<b>Location:</b>	<b>1431 Franklin Street</b>
<b>Assessor's Parcel Number:</b>	008 062100807
<b>Proposal:</b>	Major Conditional Use Permit and Regular Design Review to construct a 27-story (425-foot tall) 419,480 square feet office tower with a parking garage above grade.
<b>Applicant:</b>	TC II 1431 Franklin, LLC
<b>Phone Number:</b>	Kyle Winkler, Tidewater Capital, (510) 290-9901
<b>Case File Number:</b>	PLN20124
<b>Owner:</b>	TC II 1431 Franklin, LLC
<b>Planning Permits Required:</b>	Major Conditional Use Permit for large scale development; Regular Design Review
<b>General Plan:</b>	Central Business District
<b>Zoning:</b>	CBD-P Central Business District Pedestrian Retail Commercial Zone Height Area 7, no limit
<b>Environmental Determination:</b>	Determination Pending, Environmental analysis to be conducted prior to any discretionary action.
<b>Historic Status:</b>	Project site is located within an existing listed National Register historic resource, the Downtown Historic District Area of Primary Importance (API).

# LANDMARKS PRESERVATION ADVISORY BOARD

Case File: PLN20124  
Applicant: TC II 1431 Franklin, LLC  
Address: 1431 Franklin Street  
Zone: CBD-P  
Height Area: 7, No l

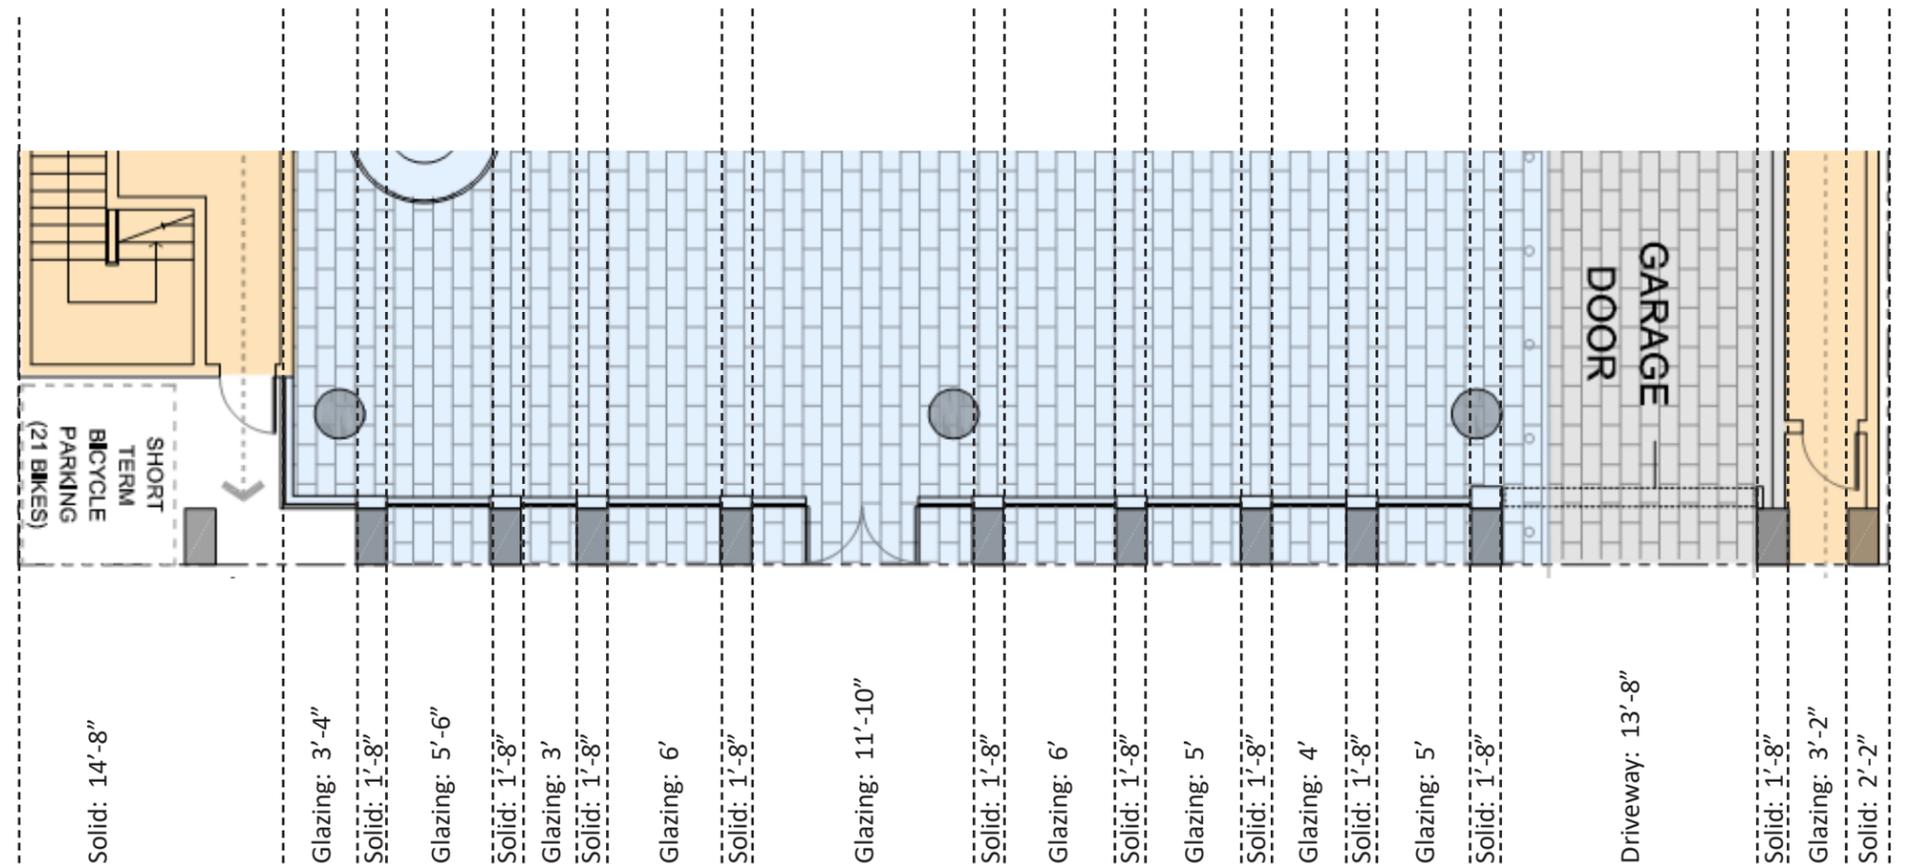
Unknown

Unclear

The ground floor plan is shown below with the proposed elevation. The diagram illustrates the amount of transparency designed for the ground floor. At present the percentage is 66.5 percent. The minimum required transparency per the Oakland Chapter 17.58 - CBD Central Business District Zones Regulations is 65 percent.

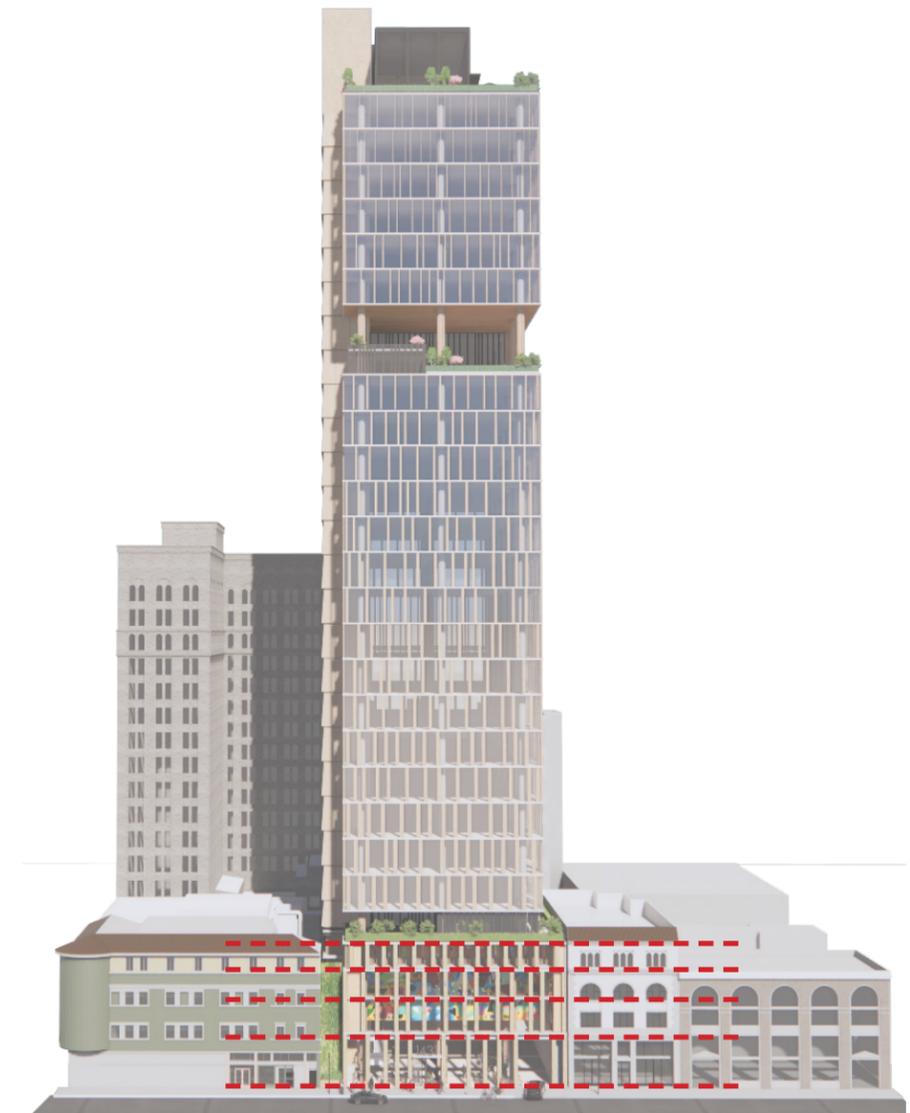
The design does not transition in terms of height and scale.

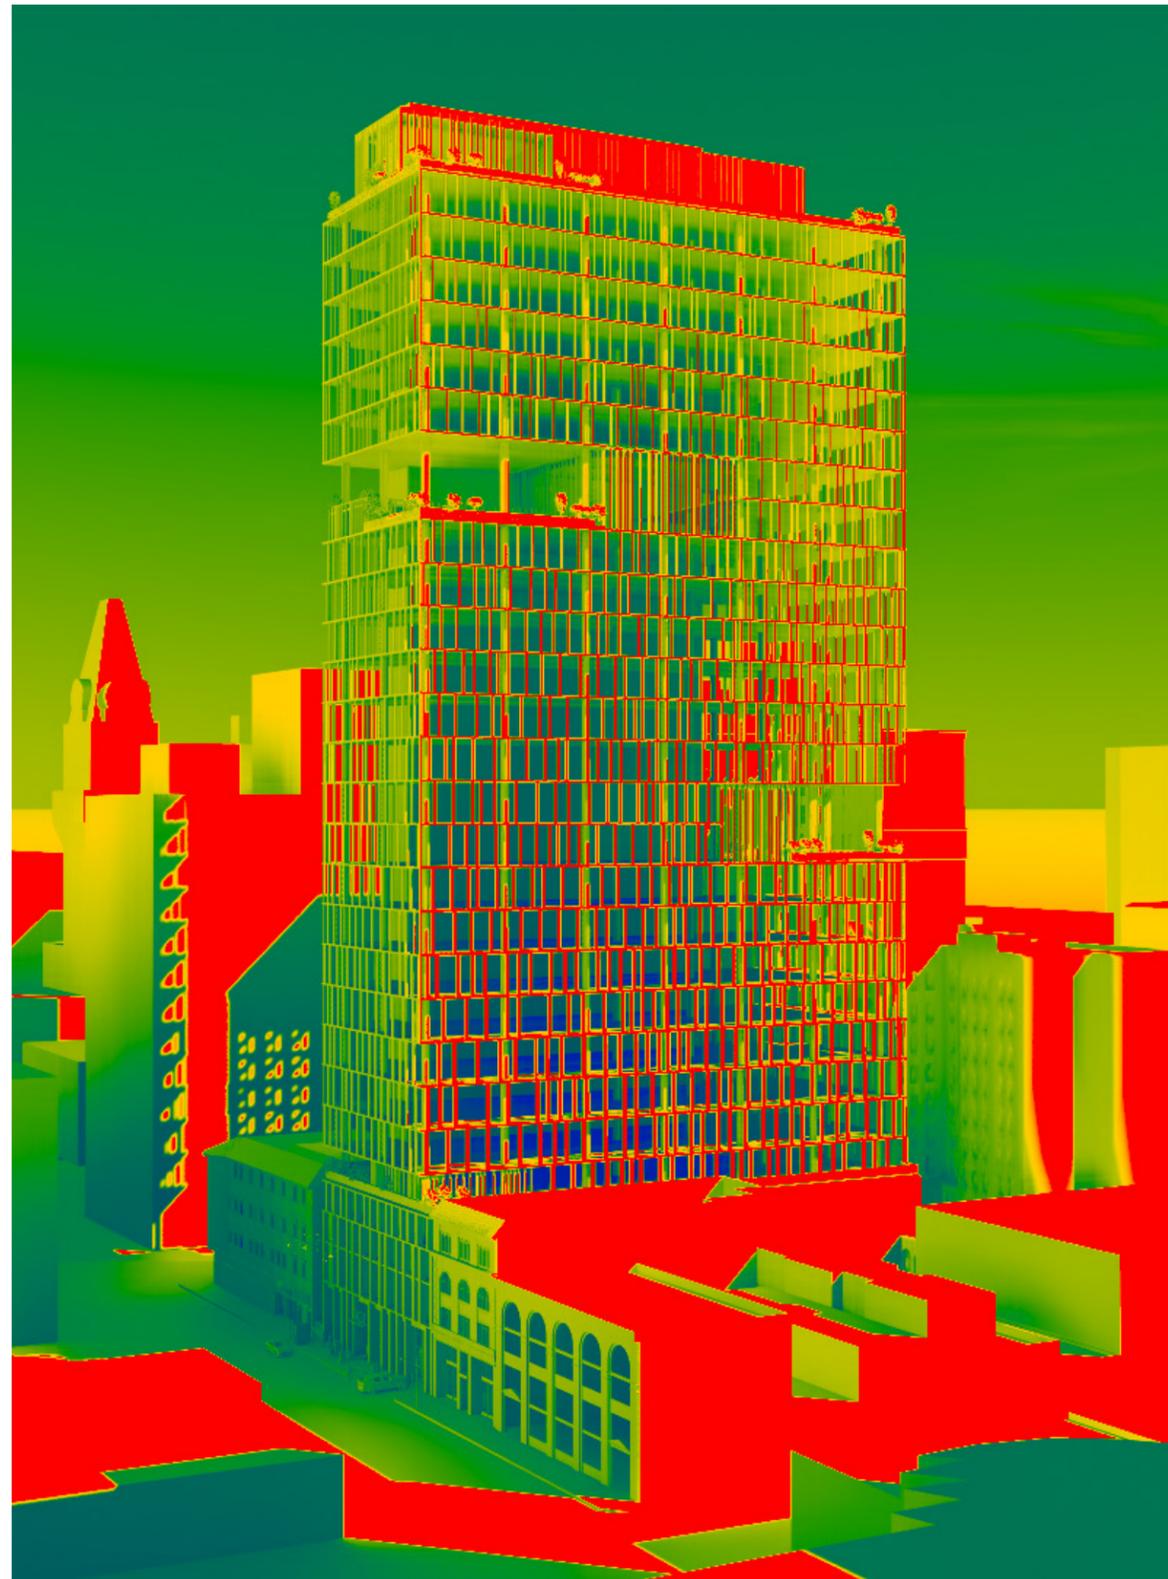
This new proposed design does not provide information on sustainable design techniques, on-site stormwater, or green building techniques.

The design of the exterior of the building will have very little to do with the real-life sustainable design techniques, on-site stormwater, or green building techniques. These are all items dealt with in great detail by Mechanical consultants during the Construction Document Phase.

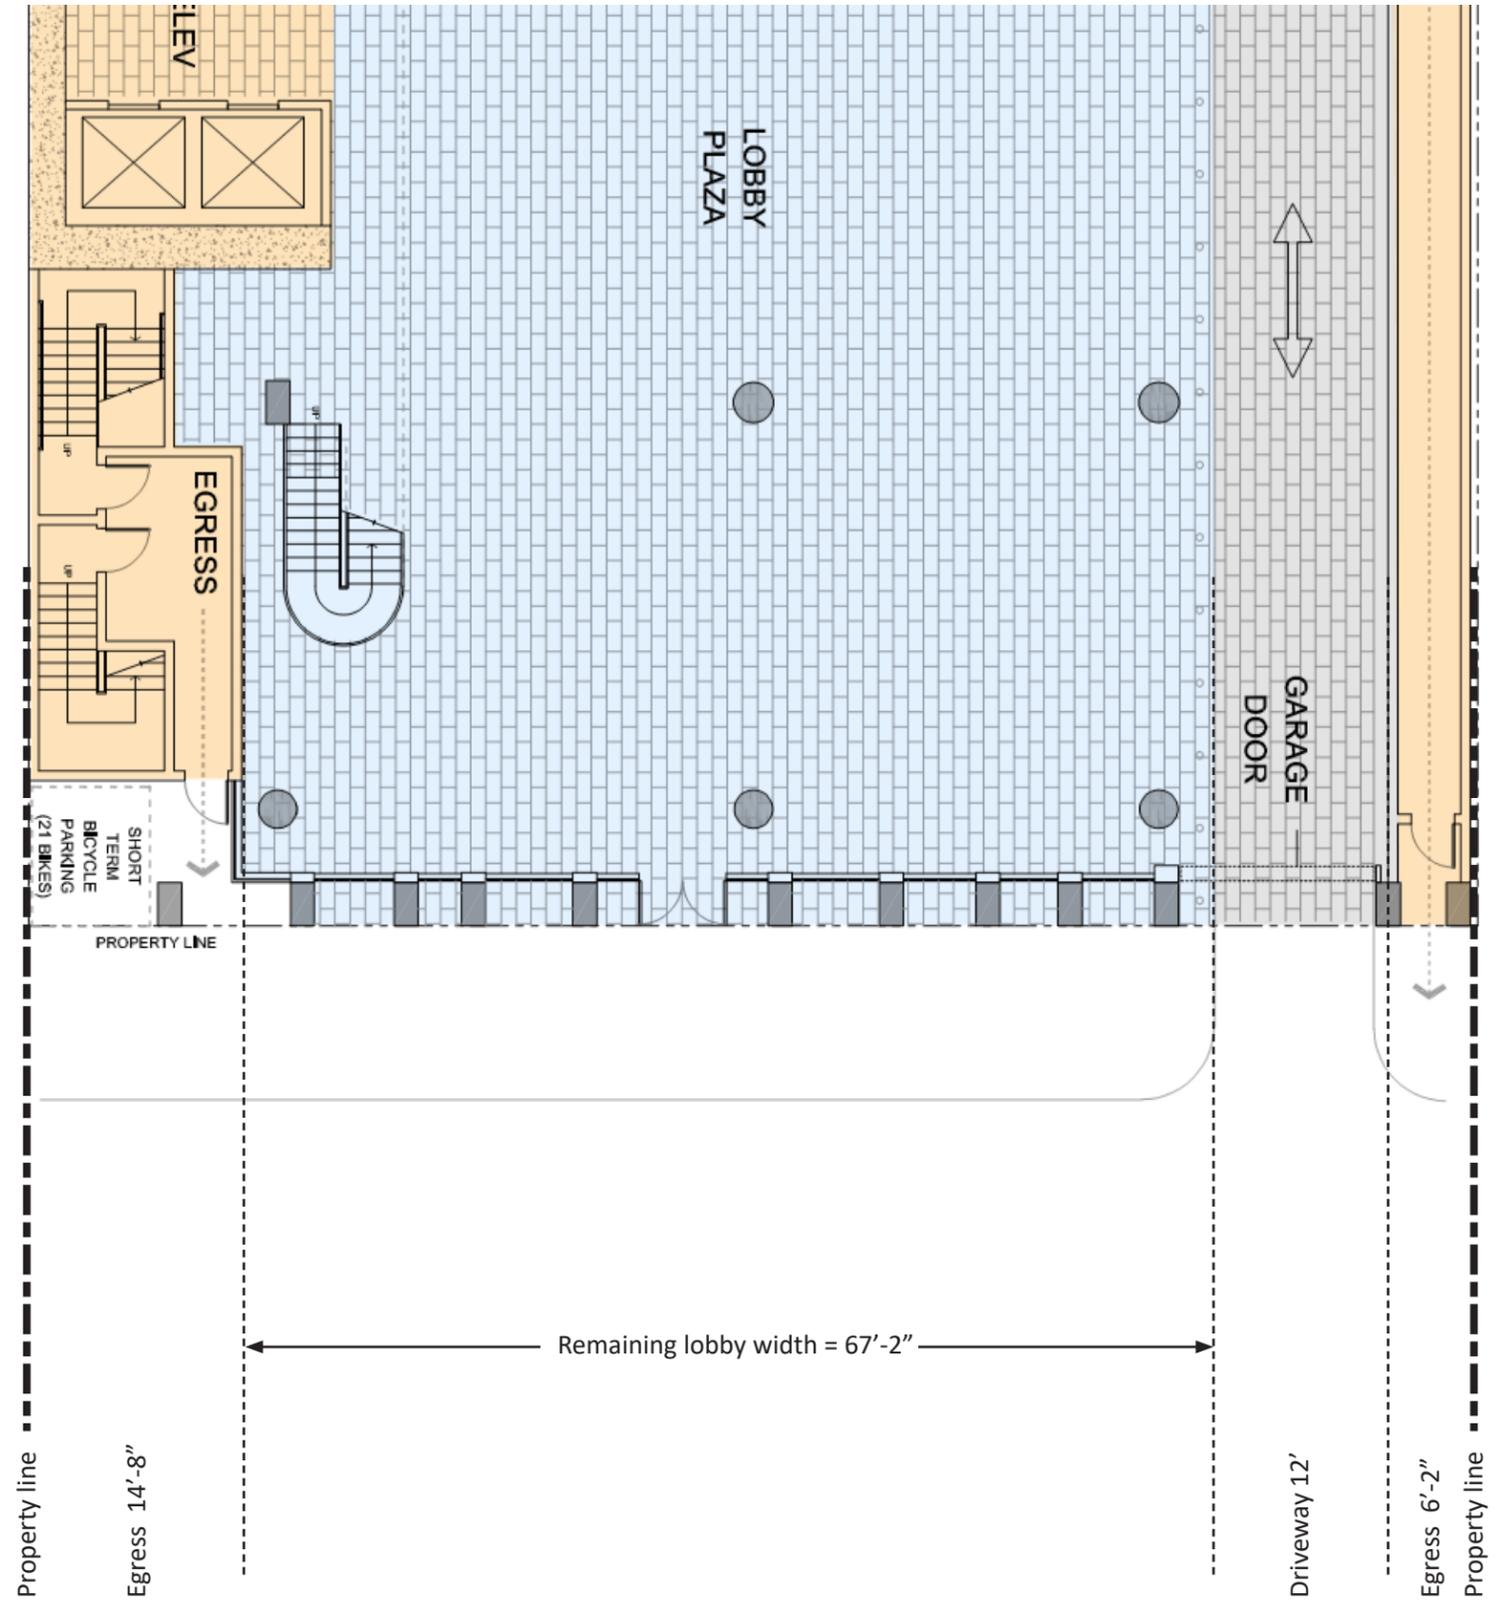
More information about the ground floor storefront/glazing materials is needed.

The building is an office building not a retail store. It would be very difficult to insert a retail space into the limited width of the site. More specifically, the site is approximately 100 feet wide. Two egresses from the proposed building are required, an egress from the adjacent building is required, access to parking is required, which in turn leaves approximately 67 feet for a lobby. This is a narrow width for a lobby that is intended for a 42-storey office building, with an elevator core, BOH, Reception desk, seating etc. To then add a realistic retail space to that lobby would make it essentially unusable.

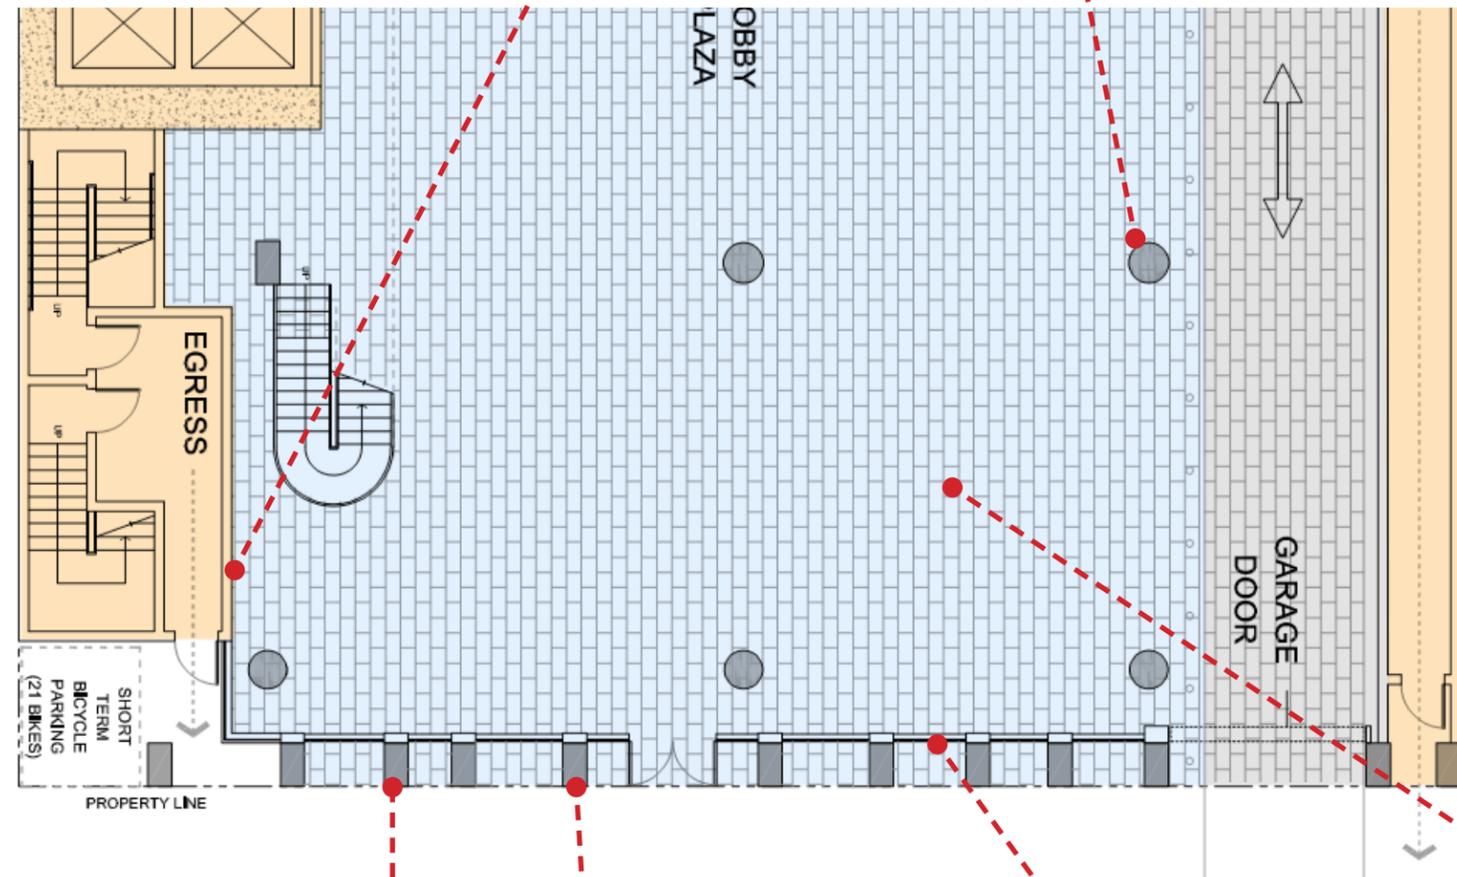
The plans provide general not specific dimensions for the lobby. More information on the columns/pillars, materials of design, proposed activity (if any) would be located at the ground level.

The proposed design is for an office building, not a commercial space. This does not seem to apply to our project. Below is a plan showing the specifics of the lobby and the finishes.

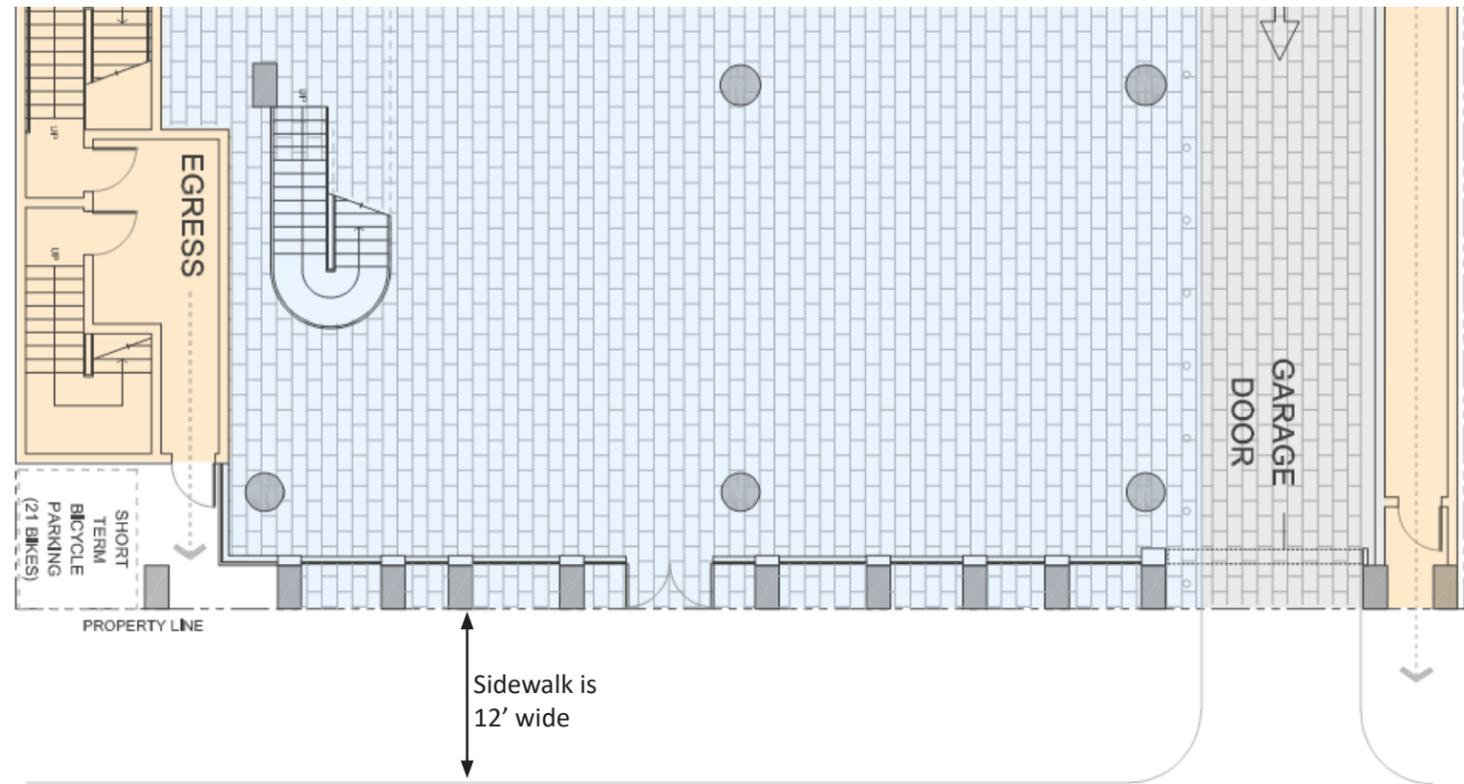
No

Presently there are no trees on Franklin between 14th and 15th, and the city does not have a street tree plan for this area nor a city requirement for trees on Franklin. We also do not feel it would be a positive addition to the street given it is an historic district and street trees were never designed for the street. The sidewalk is narrow, and a large tree planter would greatly reduce the walkability of the street. To also install trees at the front of an already narrow office façade would create a more congested experience for those leaving the office, say at lunch, and those passing the proposed office building. For these reasons, we are not proposing any trees along Franklin.
